Cowl Bracket and Handles (3.0 Liter Outboards)

Models Affected

Models Covered	Serial Number
200 - 250 3.0 Liter EFI 200/225 3.0 Liter OptiMax 225 Pro XS 250 Pro XS	0T801000 through 1B490865 0T599000 through 1B490865 1B104549 through 1B490865 1B446999 through 1B490865

32133

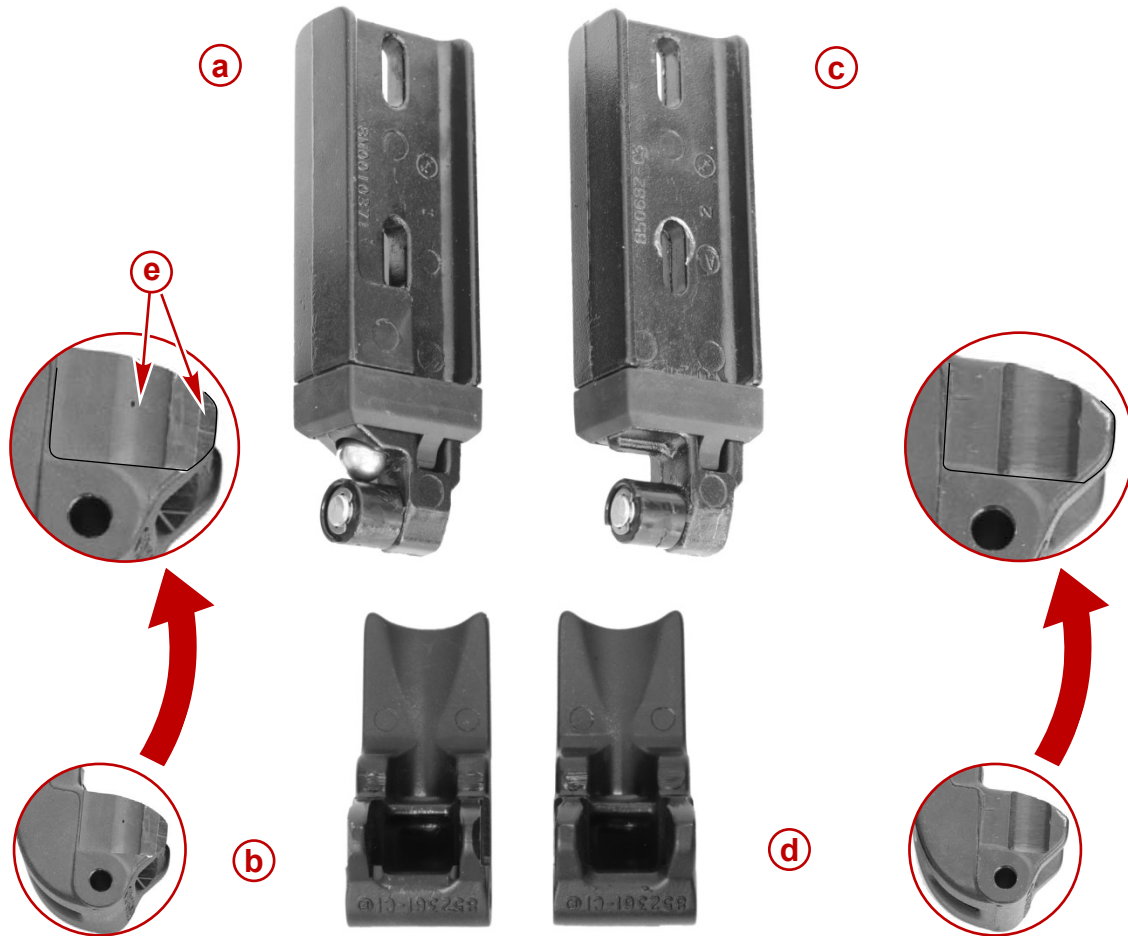
An improved top cowl bracket and lower cowl handle are being installed on current production 3.0 Liter outboards. The top cowl bracket now has a spring-loaded stainless steel ball and the lower cowl handle has a machined indentation which improves handle retention in the closed position. The new bracket and handle must be installed as a set.

Ref.	Description	Part Number
a	Top cowl bracket assembly - New design	8M0010389
b	Lower cowl handle – New design	852361T02
c	Top cowl bracket assembly - Old design	850682A 5
d	Cowl handle – Old design	852361T 1
e	Machined surface is deeper and includes a beveled edge to raise bearing	—

NOTE: The old bracket and handle will become no longer available (NLA) and will be replaced with kit P/N 850682A06. The kit includes two new style brackets, handles, mounting hardware, and instruction sheet.
